Job location:
204 E F St,
Erwin, NC 28339

June 21, 2019

Re: Limited Structural Inspection
204 East F Street
Erwin, NC

204 EAST F STREET, ERWIN (REPAIR PLAN)
SCALE: NTS

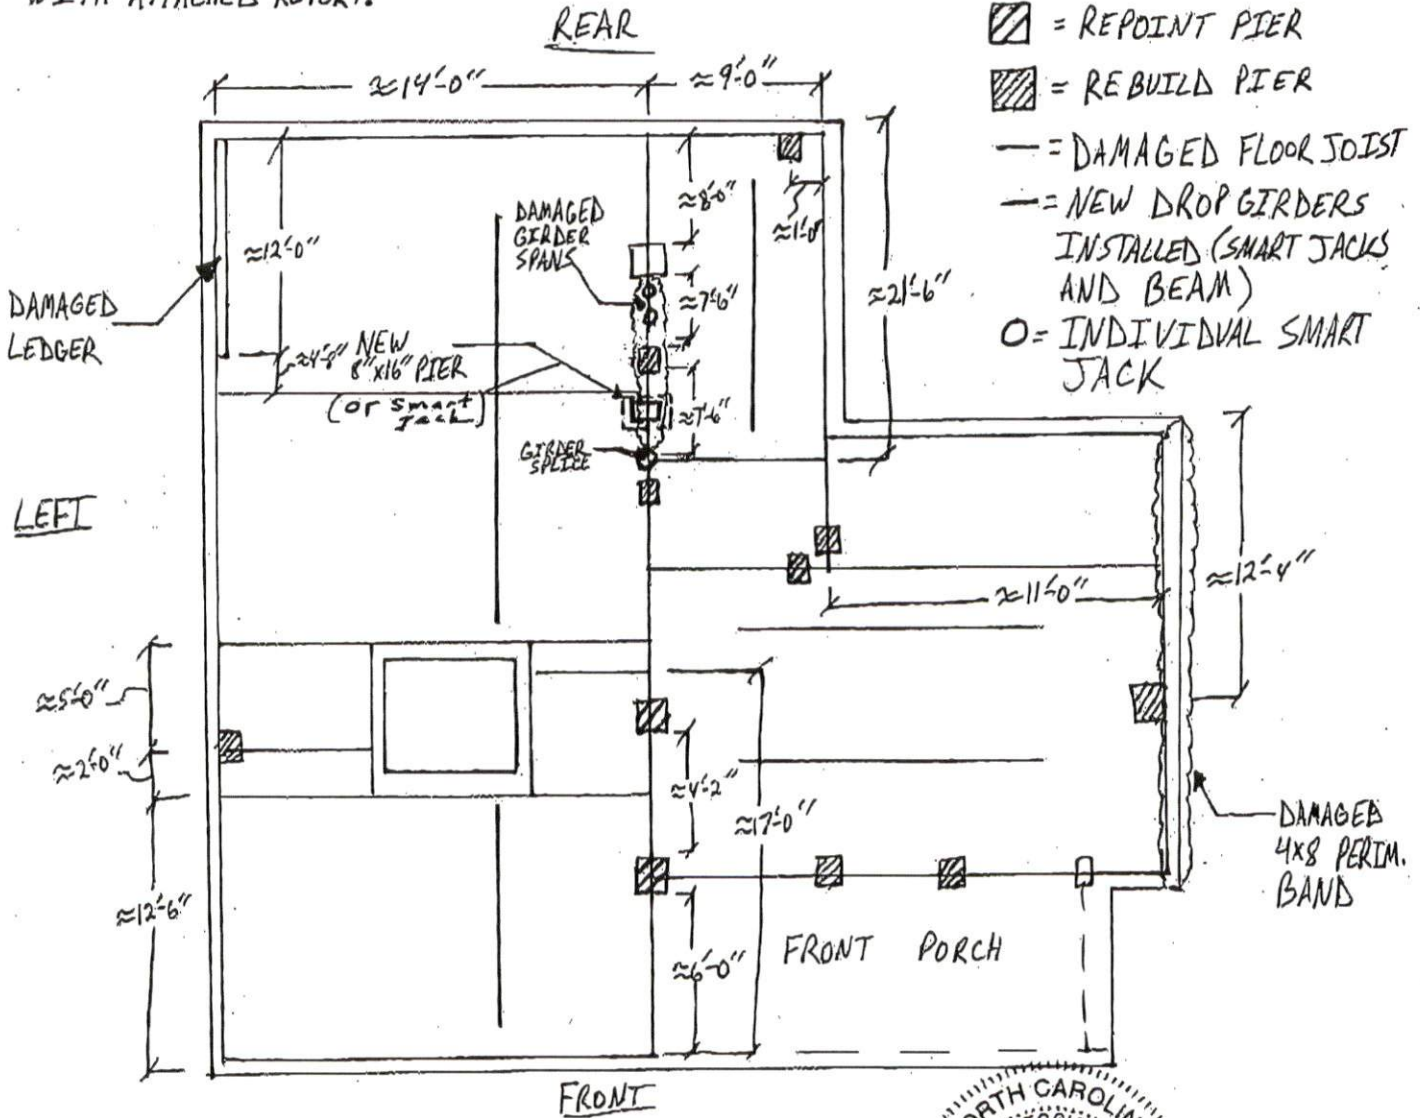
3. Multiple additional observations were noted in the crawlspace. Refer to the attached sketch for locations of damages observed.
 - a. Multiple partially sistered and damaged floor joists were observed throughout the crawlspace.

5. At the piers noted "REPOINT PIER" on the attached sketch, we recommend re-pointing the piers or we recommend installing a fibrous cement coating on the piers.

6. At the piers noted "REBUILD PIER" on the attached sketch, we recommend replacing the damaged piers with new mortared 8"x16" CMU block piers. The new piers are to be supported by a minimum 12"x20"x8"-thick concrete footings on firm, dry soils. Note, all exterior footings are to be installed a minimum 12" below grade to the bottom of the footing and all interior footings are to be installed a minimum 8" below grade to the bottom of the footing.

1. We recommend fully sistering the damaged, partially sistered, and cut floor joists for the full length (bearing point to bearing point). The new sistered member should match the size of the existing joist and be attached with (3) 16d nails at 16" on-center.

2. At the damaged ledger board, we recommend attaching the floor joists to the perimeter band with Simpson Steel Clip Angles (or equivalent).
3. We recommend replacing the perimeter band along the right perimeter wall with a new pressure treated 3-2x8 member.

4. We recommend replacing the damaged sections of central girder with new pressure treated 2-2x8 members.
 - At the girder central girder spanning front to rear (approximate 7'-6" span) located approximately 20'-0" from the rear perimeter wall, we recommend centering the smart jack directly below the splice to support both ends of the girders. We also recommend installing a new mortared 8"x16" CMU pier at the mid-span supported by a new 12"x20"x8"-thick concrete footing installed a minimum of 8" below grade on firm, dry soils. Note, a smart jack may also be installed per manufacturer's specifications at the mid-span.
